RIIO-2 Draft Determinations – WWU response

We welcome the opportunity to provide our views on the RIIO-2 Draft Determinations issued on 9 July 2020.

Figure 1: WWU's RIIO incentives in RoRE terms

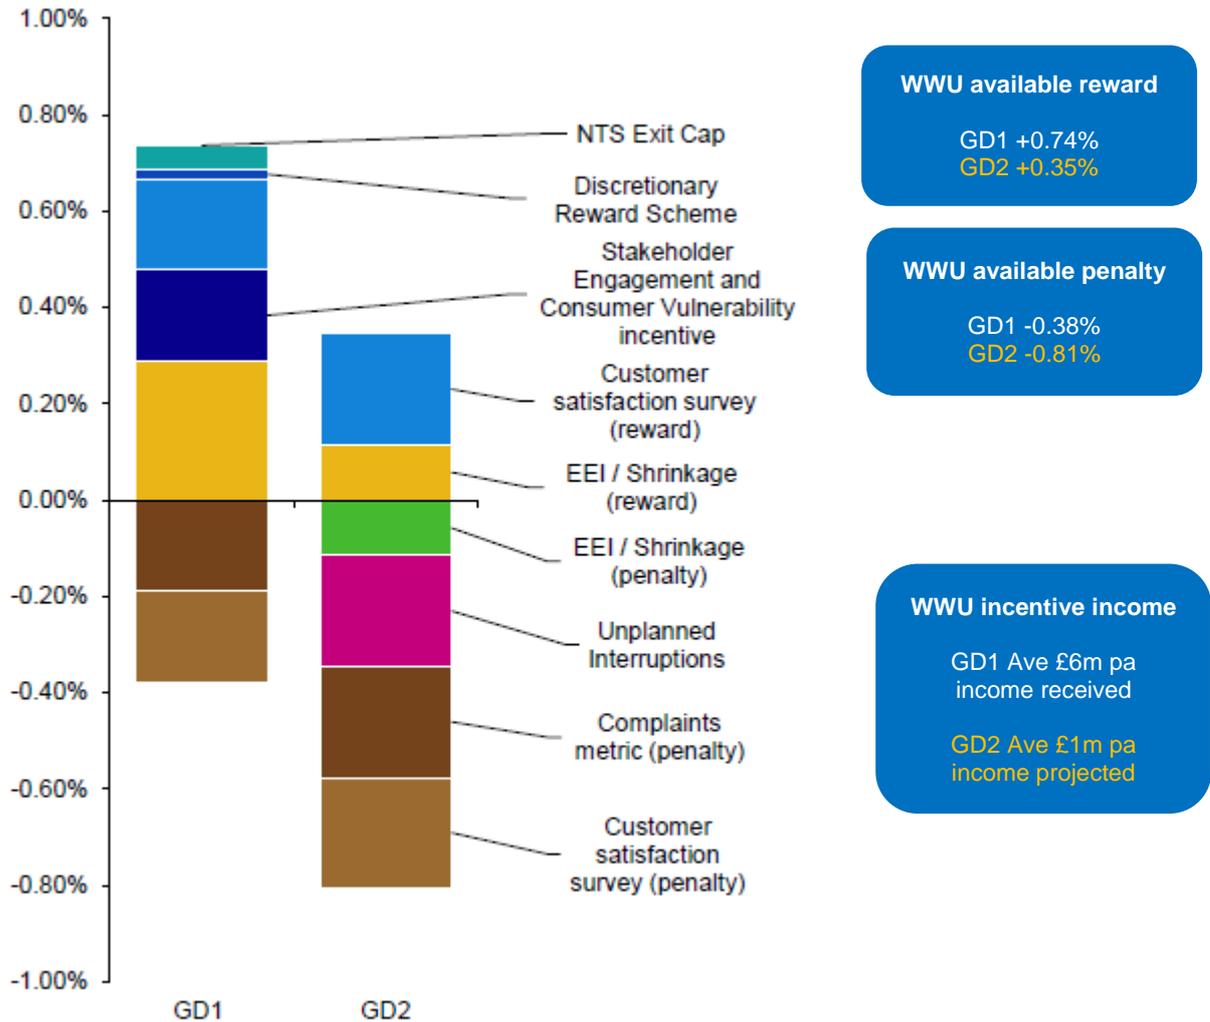
Decreased Incentive Opportunity - £27m shortfall

The DD represents a significant move away from the incentivisation framework introduced in RIIO-1, to the extent there is no realistic incentive for companies to deliver enhanced performance in GD2. This is shown in the figure below:-

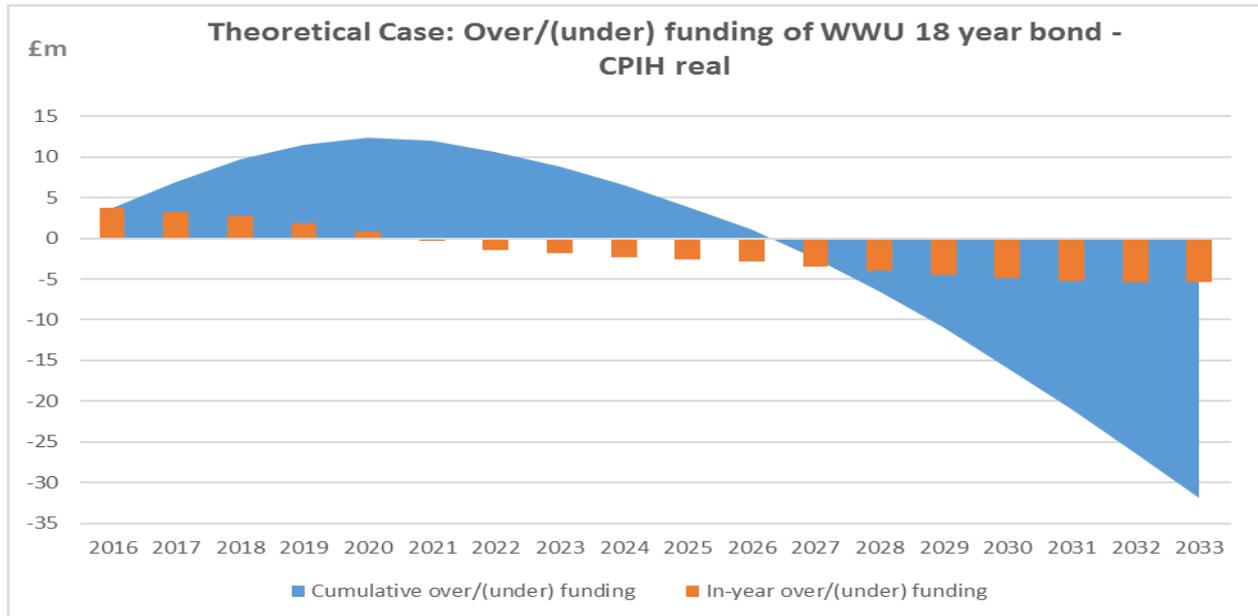
Ofgem’s method is fundamentally flawed because it does not provide assurance on an ex ante basis that the cost of every debt instrument, raised efficiently, would be allowed over its life. To illustrate, and using Ofgem’s own data set, we took an example of an 18 year bond raised in 2015 - it will be seen below that an overall shortfall would arise over the life of that instrument.

This lack of assurance, at the outset of each debt instrument raised efficiently, combined with Ofgem’s methodology, means that an efficient network would only receive an allowance equating its efficient cost, at notional leverage, through pure chance, rather than through efficient execution and management. No permutation of calibrating trailing average indices or fixed rate methods on sector wide average costs can ever ensure that allowances are accurately applied to efficient costs at a notionally geared individual network level.

There are 3 key messages in the graph below:

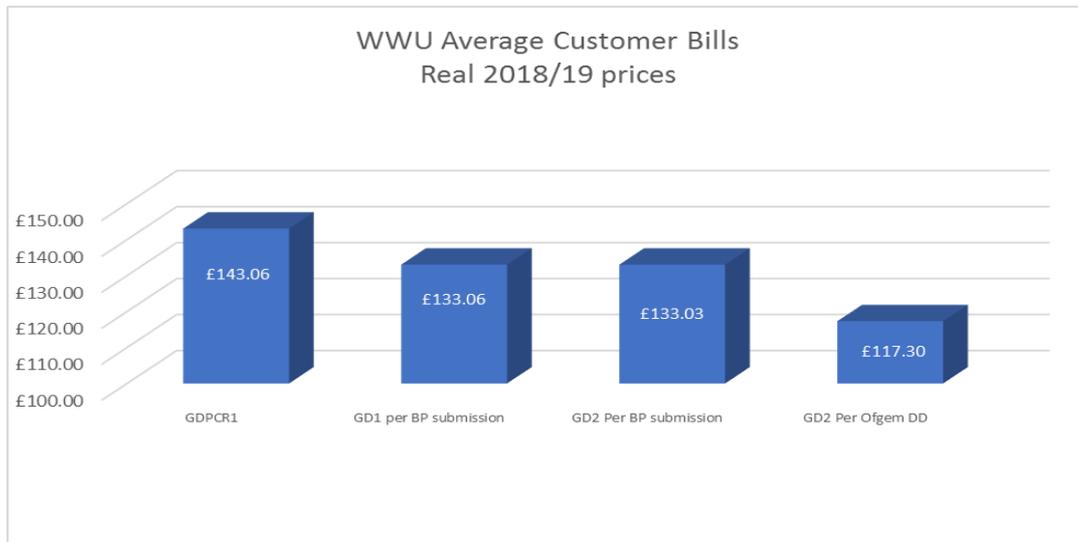
- GD1 bill level – reduction of 7% over prior control GDPCR1 from £143 to £133
- WWU's Business Plan for GD2 – no increase over GD1 of £133
- Ofgem's DD – £117.30, a reduction of 12% over GD1, following a reduction of 7% over GDPCR1. This is not a sustainable bill, for reasons explained above.

A severe cut to bill levels in GD2, for a business that is operated and financed efficiently, will harm capital employed, and be detrimental to consumer interests in the medium to long term.

The following graphs show the impact of varying Repex annual programme lengths on repairs for Tier 2B and iron >30m.

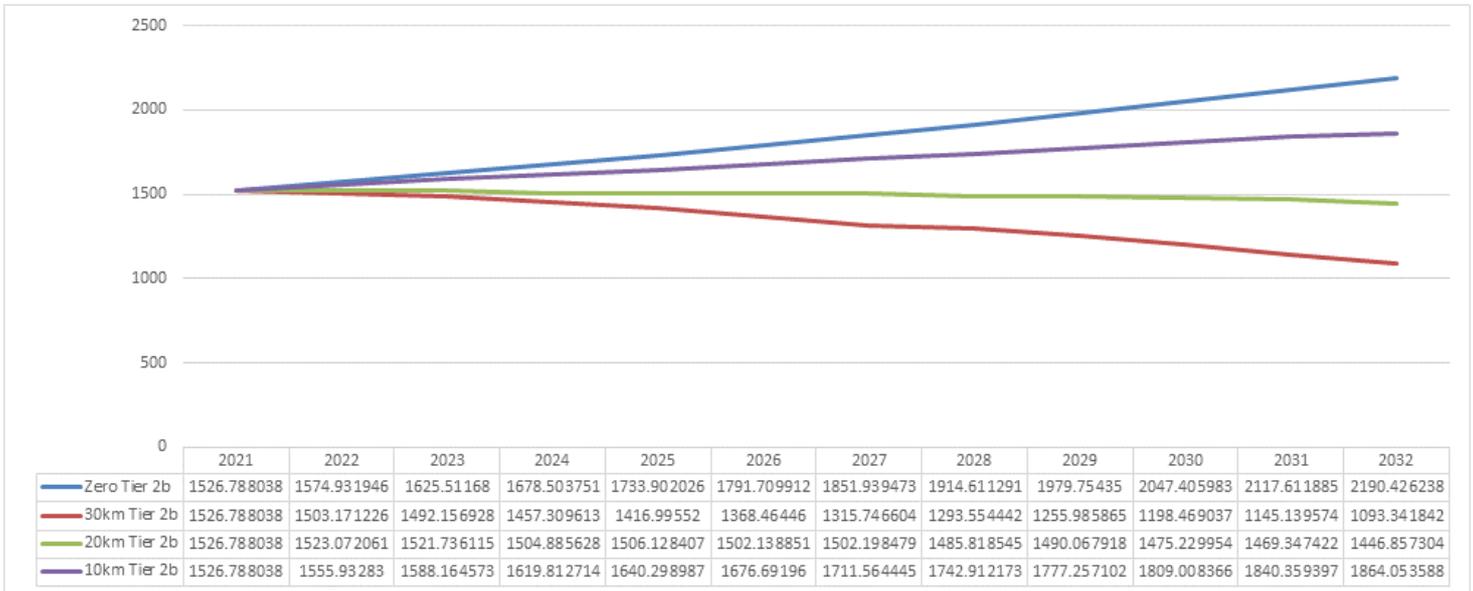
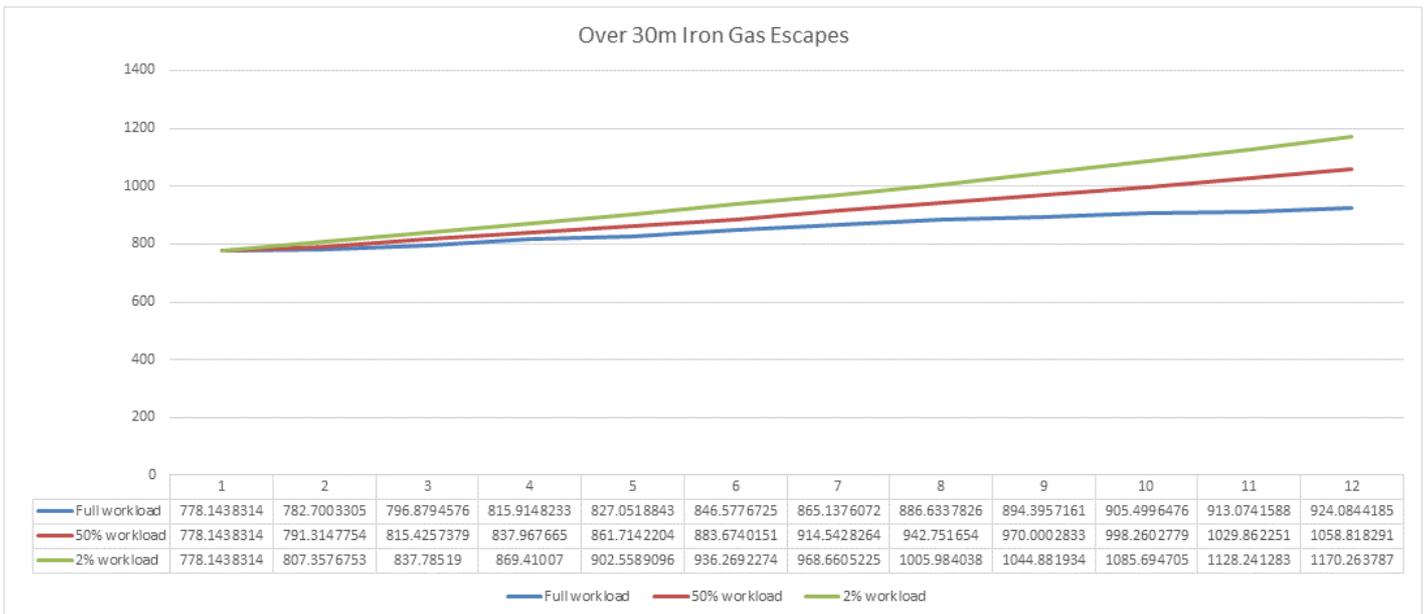
Disallowing Repex has a direct impact on future Opex costs. There is a clear link proven and we have modelling to demonstrate the impact of our current disallowed Tier 2B and iron >30m workloads on repairs and associated costs. Any disallowance of Repex requires the Opex to be funded.

This analysis shows that the disallowed workload results in 1,340 additional repairs per annum by the end of the mandatory programme (2032). This causes significant disruption, Opex costs and emissions to atmosphere that prevent us from achieving Net Zero.

We have analysed the cost to consumer. Our planned repex programme for tier 2B and iron >30 would cost consumers circa £1.25 over GD2. The cost of repairs with no programme would cost consumer £5 over GD2. It is clear that the best outcome for customer bills is the allowance of our planned programme.
